Subject: Response to request for additional information letter dated September 8, 2008 for the Missouri University of Science and Technology Reactor (MSTR) Facility, R-79, Docket 50-123.

The Missouri University of Science and Technology Reactor (MSTR) Facility is responding to the request for additional information that was submitted to us in letter dated September 8, 2008. The following are the questions and the MSTR response:

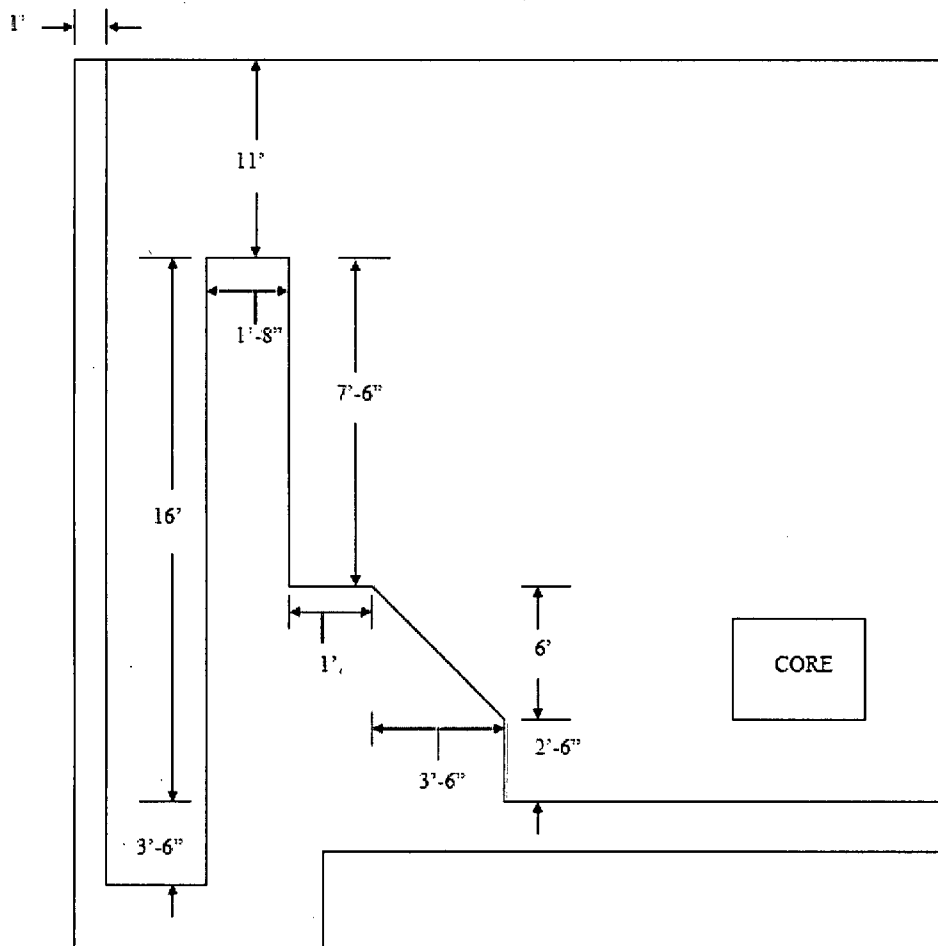
6. Section 9.2, "Handling and Storage of Reactor Fuel". Provide dimensions of the wall that separates the main pool and the fuel storage pit.

The following diagram contains dimensions of the bulkhead within the reactor pool. The one foot dimension on the left side of the drawing is a pool wall. The right side of the drawing only shows the pool side of the wall without wall thicknesses. The pool is nineteen feet long from left to right.
